Thames Crossing Action Group represents thousands of people who are strongly opposed to the proposed Lower Thames Crossing. We object to the proposed Lower Thames Crossing for many different reasons and do not consider the project to be in any way fit for purpose.

Inadequacies of London Resort Consultation

LR PEIR Fig 9.2 Highway Traffic Model Extent -

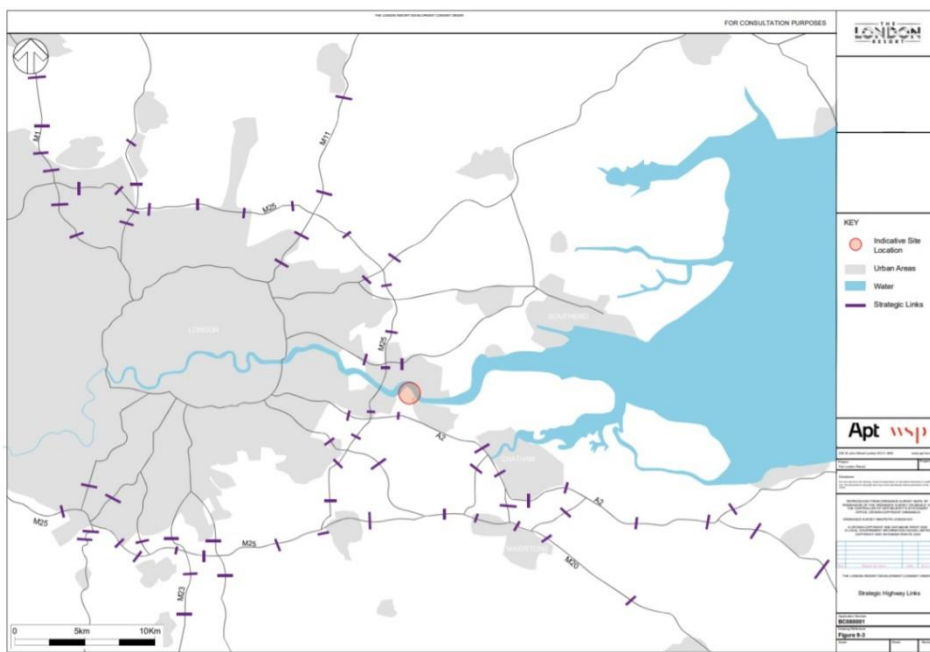
This document is incorrect as London Resort have the A13 near Stanford-le-Hope labelled as the A1089 (circled in pink on the image above). Considering that the A1089 is the route they are proposing traffic access the proposed parking facility in Tilbury this is very misleading and poor performance from LR to not even be able to identify and label it correctly on a map.

In addition the actual A1089 is not even marked in green on the map, which is supposed to show model links. Again considering traffic will have to use the A1089 to access the parking facility in Tilbury this is unacceptable and very concerning that they have failed to include it.

There are also routes marked in green that do not make sense as to why they should be included. Some of the green highlighted routes include very small/short isolated sections, which again make no sense. (We have circled the most random ones in red on the image above.)

We particularly enquired via email about the inclusion of Baker St, High Rd, Rectory Rd in Orsett (circled in blue in image above), and were told, *"These links have been included due*

Since none of these three roads are directly accessible from the A13 this doesn't provide a clear and informative reply. However, it would suggest that if this is the case that other junctions and roads should also be highlighted, simply by fact that they would need to be used to access these roads alone.

The map used in this document doesn't even clearly show the fact that these roads are not directly connected to the A13.

We can in no way understand why LR have highlighted the 'junction' for want of a better word that we have circled in orange. Again this is not a route that is directly accessible from the A13 as their map gives the impression of. It is also a very strange assumption to come to that this route would be impacted, and there is no explanation as to why.

LR are including the proposed Lower Thames Crossing in this map, yet LR are not highlighting the Stanford-le-Hope junction on the A13. Any traffic attempting to use the LTC (or indeed the Orsett Cock junction of the A13, including the A128 traffic) to access the A1089(south) would all have to detour to the Stanford junction to go up and around the traffic lighted roundabout and head back westbound on the A13 to reach the new proposed joint LTC/A1089(south) junction to access the A1089 southbound to the proposed London Resort Parking facility in Tilbury.

When we raised this point via email with LR we were told, *"We agree that this link may be used to reach the Tilbury parking facility. We will include this link, along with many others, within the traffic modelling as we progress."*

to the potential changes in traffic flows along the A13 which could impact upon local communities within the vicinity.”

LR PEIR Fig 9.3 Strategic Highway Links -

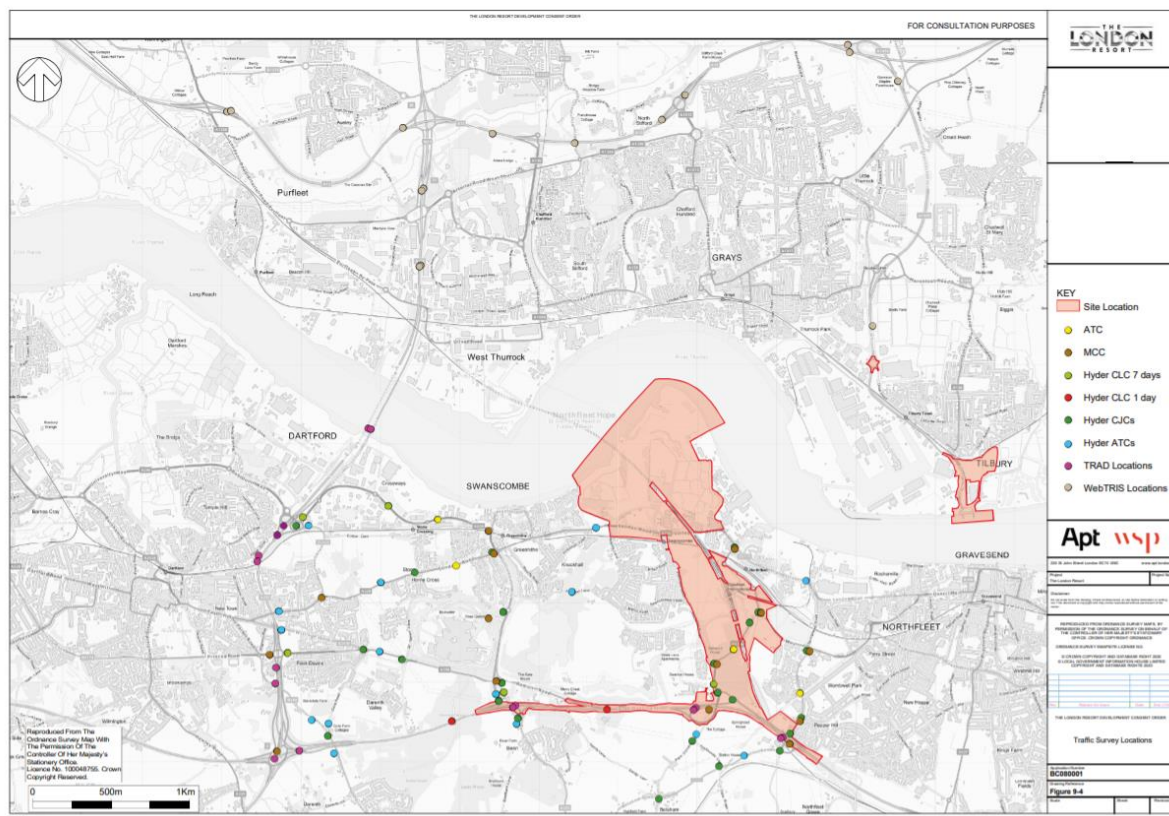
The map above is supposed to show strategic links. How can lines marked on a map without any labelling be considered adequate? It is not even clear whether the A1089 is marked on this map or not. Some of the lines intersect routes, but do not show what junction it is, or indeed even the route which it is on, as only a few random roads are actually labelled.

The proposed parking facility to the north of the river in Tilbury is not even marked on the map either.

Clearly this is not the case as figure 9.3 is an inadequate poorly labelled image which does not provide clear and informative detail that is legally required for an adequate consultation.

LR PEIR Fig 9.6 Strategic Highway Network –

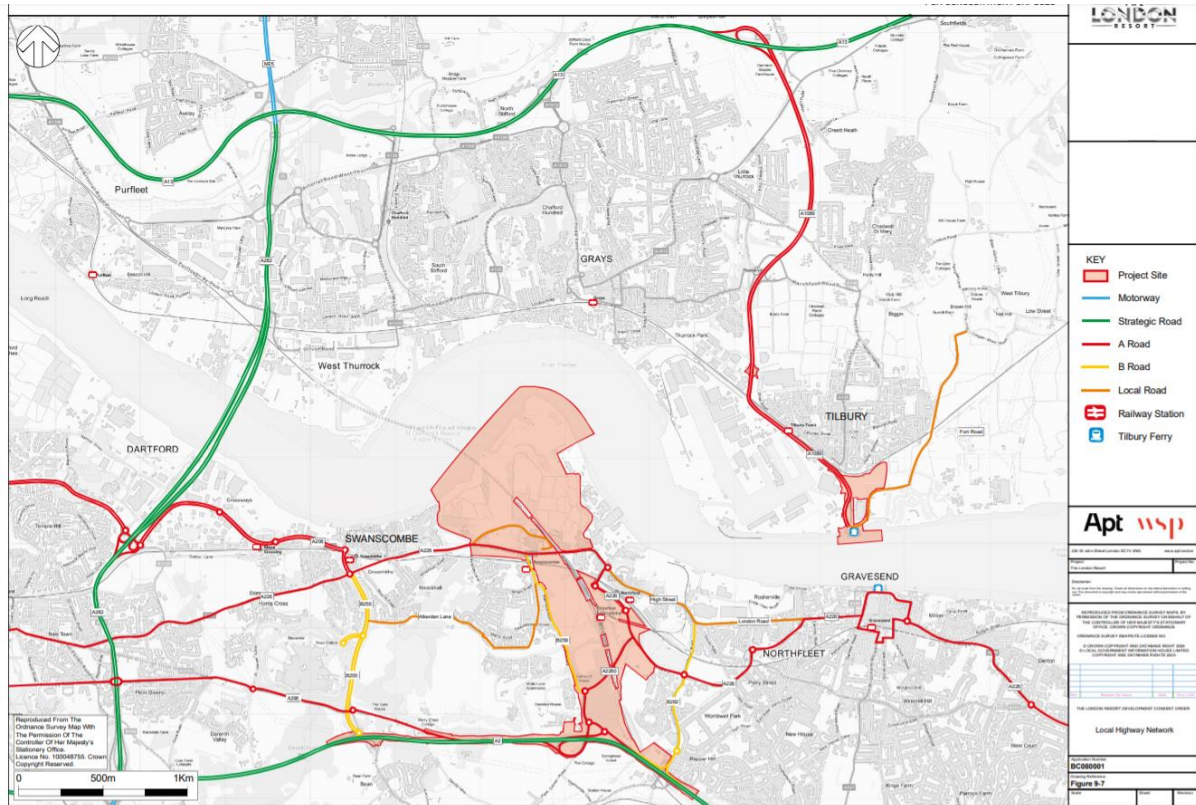
The figure above is supposed to show the Strategic Road Network. However LR have glaringly omitted to include the A13 up to the A1089, and the A1089 itself, both of which are part of the Strategic Road Network. Yet another inadequacy of the consultation materials, and proof of lack of clear and informative materials.
